### REMARKS

Reconsideration of the instant application is respectfully requested. The present amendment is responsive to the Office Action of May 28, 2003, in which claims 1-31 are presently pending. Of those, claims 1-5, 7-11, 13-17, 19-23 and 25-30 have been rejected under 35 U.S.C. §102(b) as being anticipated by U.S. Patent 5,114,240 to Mehdizadeh, et al. In addition, the remaining claims 6, 12, 18, 24 and 31 have been rejected under 35 U.S.C. §103(a) as being unpatentable over Mehdizadeh, in view of U.S. Patent 6,522,140 to Harvey. For the following reasons, however, it is respectfully submitted that the application is now in condition for allowance.

**FIG. 2**  
PRIOR ART

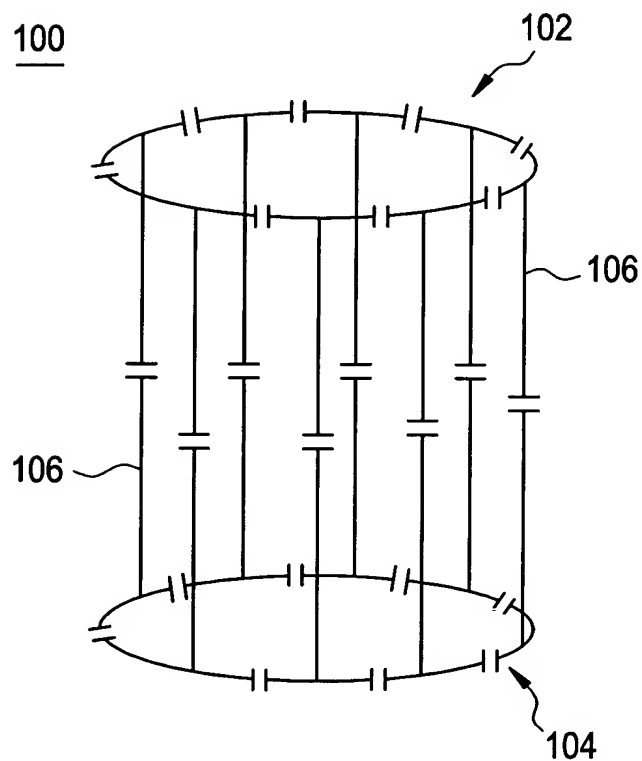
Figures 1 and 2 have been amended as indicated above to include the legend -- Prior Art--. Accordingly, it is respectfully requested that the objections to the drawings be withdrawn.
